**Government Departments' General Comments**

**Recommended Advisory Clauses**

Section 16 Application for Temporary Public Vehicle Park (Private Cars Only) with Ancillary Electric Vehicle Charging Facilities and Ancillary Solar Panels and Associated Filling of Land for a Period of 3 Years at Lot No. 241 in D.D. 23 at Ting Kok, Tai Po, New Territories

Part print of sheet

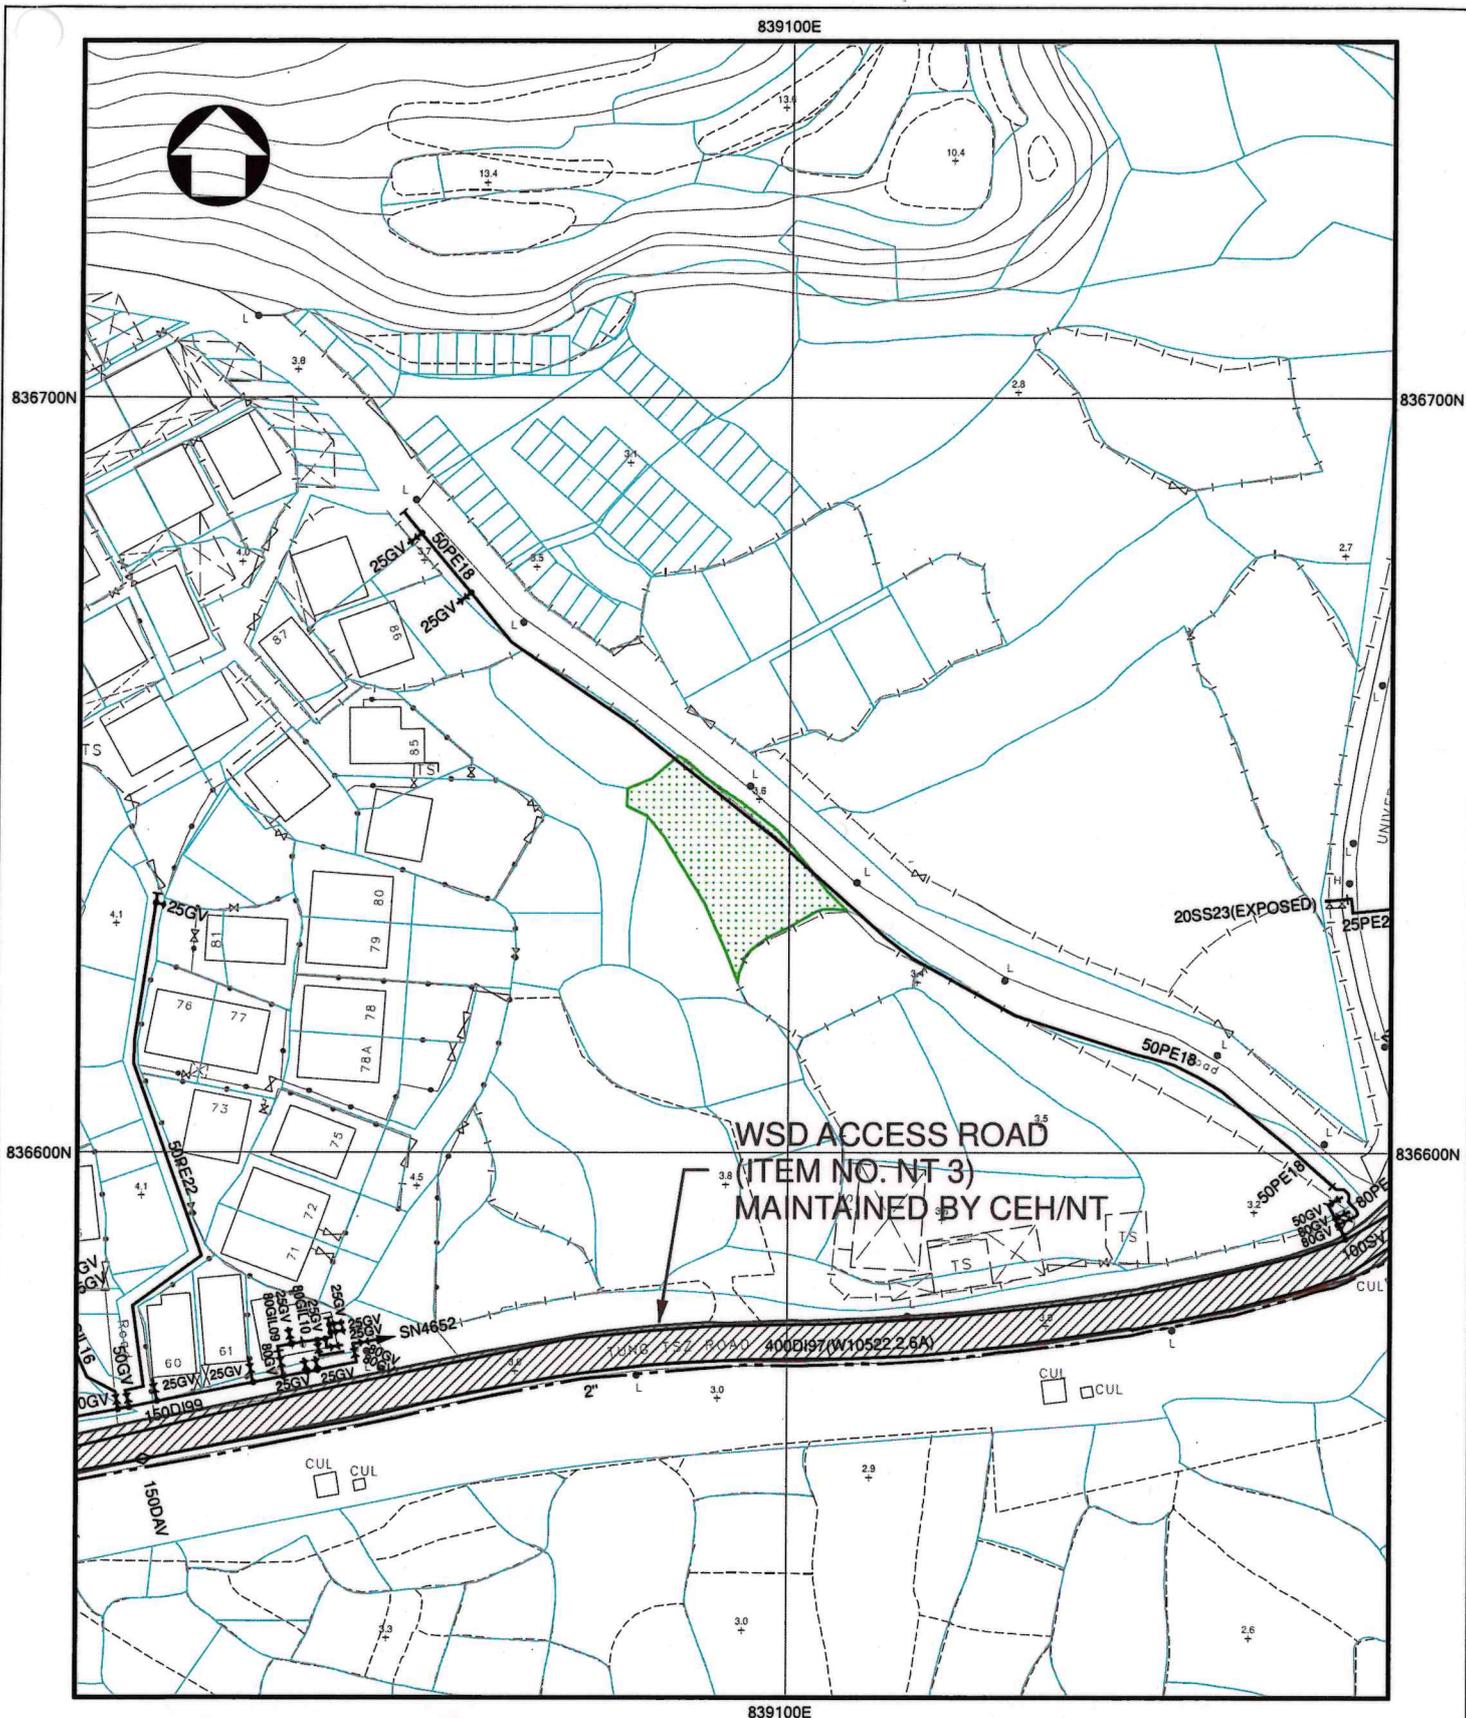
- (ii) there is existing public sewer in the vicinity of the Site. The drainage record plan is at **Attachment 1** for ease of reference;
  - (iii) the applicant shall resolve any conflict/disagreement with relevant lot owner(s) and seek LandsD's permission for laying new drains/channels and/or modifying/upgrading existing ones in other private lots or on GL (where required) outside the Site;

- (iv) please find the comments below on the drainage proposal:
    - (1) please provide sectional views to demonstrate the relationship between the proposed site formation level of the Site, topography of the adjacent area and the proposed drainage facilities;

- (2) the proposed underground pipe will have conflict with the existing box culvert under the carriageway, please review;

- (3) please provide numerical derivation of the rainfall intensity; and
  - (4) reduction in flow area should be taken in account in accordance with Section 9.3 of SDM; and
